SERVICE BULLETIN 26

SUBJECT: GLASAIR RG NOSE GEAR DRAG BRACE REINFORCEMENT

APPLICATION: GLASAIR RG LANDING GEAR SERIAL Nos. 01 thru 230  
(Serial number is stamped on the landing gear struts)

FIGURE (1)

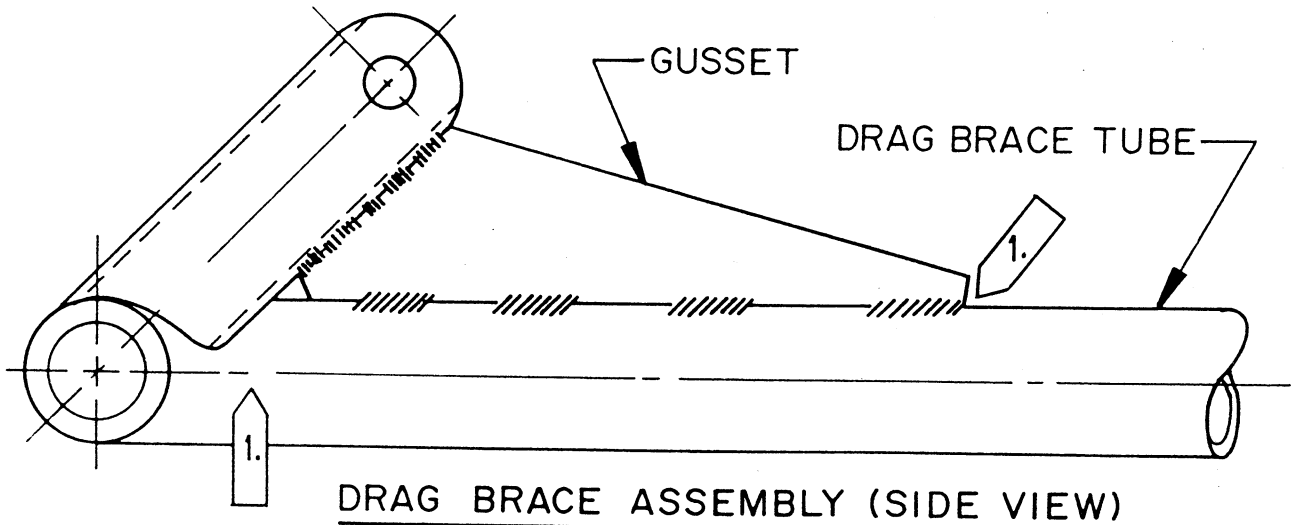
1. INSPECT TUBE AND GUSSET FOR CRACKING

COMPLIANCE: MANDATORY All Glasair RG's currently flying must comply with the nose gear drag brace reinforcement prescribed in this service bulletin by July 1, 1987. A pre-flight inspection of the drag brace, in the areas indicated by Flag no. 1 in FIGURE (1), must be performed prior to each flight until compliance with this service bulletin is made.

FIGURE (2)

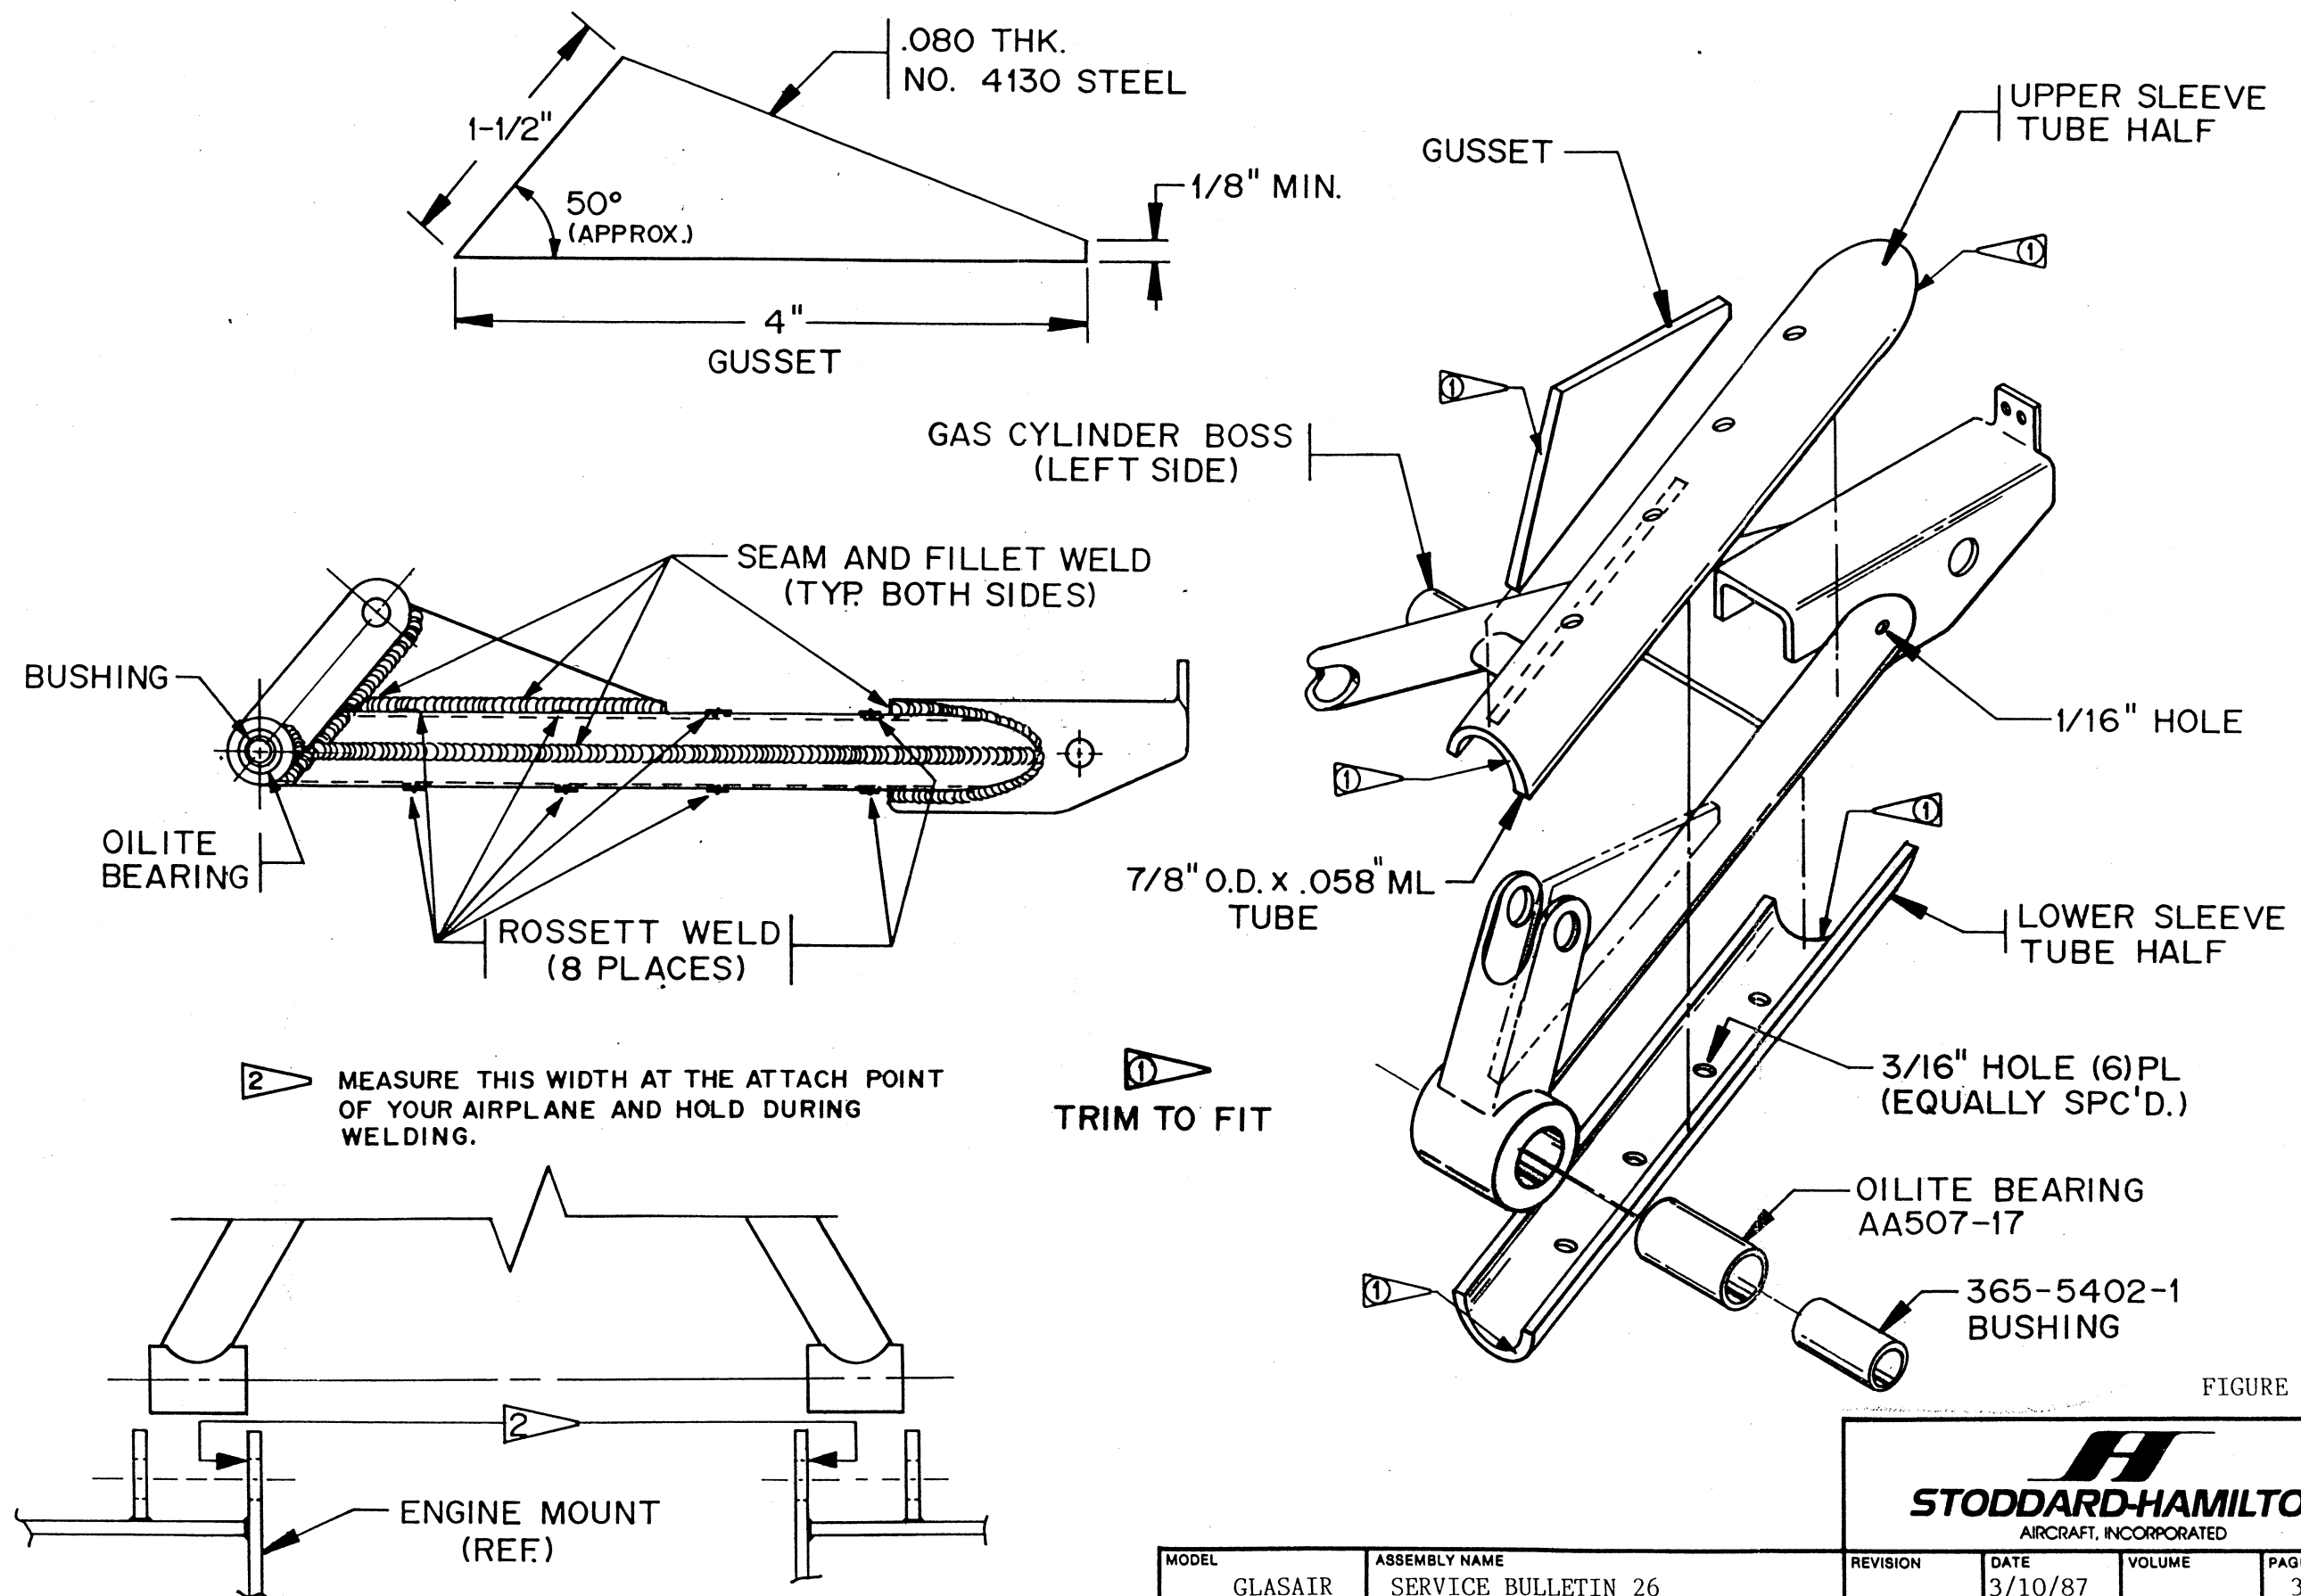
Glasair RG nose gear drag braces with landing gear serial numbers 01 thru 70 are made from 3/4" O.D. x .035" wall 4130 steel tubing; drag braces with serial numbers 71 thru 230 (approx.) use 3/4" O.D. x .049" wall tubing; and drag braces with serial numbers 231 thru 290 use 3/4" O.D. x .083 wall tubing and a thicker .080" gusset. To determine whether your drag brace has the heaviest tubing (.083" wall thickness), measure the thickness of the gusset that spans from the right brace tube to the actuator arm (short square tube). The gusset thickness is .080" thick on drag braces fabricated from .083" wall 4130 tube. Drag braces with .083" wall thickness tubing are strong enough to withstand some adjustment error over time. Drag braces with the thinner wall tubing (.035" and .049") do not have adequate strength and, therefore, must be reinforced.

SOLUTION: All Glasair RGs with earlier drag braces (landing gear serial numbers 01 through approximately 230) manufactured with the thinner wall tubing (.035" and .049"), must have the drag brace arms on the hydraulic actuator side reinforced. To accomplish this we list three options:

STEP 1 If the aircraft is assembled, place the aircraft on jacks and remove the drag brace strut. Measure the distance between the engine mount attach points of the drag brace, as shown in FIGURE (2) Flagnote 2. This dimension must be held during welding to ensure drag brace fit when the aircraft is reassembled.

STEP 4 Use 7/8" O.D. x .058" wall 4130 steel tubing to form a sleeve over the existing right drag brace tube, as shown in FIGURE 2. Drill a 1/16 inch hole (as shown) in the original drag brace tube to relieve internal air pressure during the welding process. After cutting the 7/8" tube to the correct length, slice the tube lengthwise and bevel the ends to fit. Drill 3/16" holes for rosette welds approximately every 2" top and bottom, as shown. The rosette welds add additional strength to the repair. Be sure the reinforcement sleeves extend from end to end along the entire length of the existing tube.

STEP 6 Weld the reinforcement sleeve tubes to the right drag brace tube, as shown in FIGURE 2. After welding the reinforcement sleeves, fabricate a new gusset from .080" thick 4130 steel sheet, and weld this in place of the original thinner gusset, as shown in FIGURE 2.

1. Check the splice sleeves on the drag brace to ensure proper fit. Make sure that there is no rocking of the sleeves on the drag brace tube and that there are a minimum of 1/8" gaps along the split lines between the sleeves before welding. Some additional grinding may be necessary. (It is important that the sleeves are welded to the original tubing.)
2. Clamp the splice sleeves on the drag brace, as shown in FIGURE 2.
3. Weld the rosettes first and then remove the clamps. Start welding in the center of each remaining weld and work outwards.
4. Leave the 1/16" gas hole open until after the gusset is welded on, and then weld the hole shut.

5. Be sure to weld the reinforcements completely around their circumferences and that all rosette welds are sealed, so that no moisture may enter between the original tube and the reinforcement sleeves.
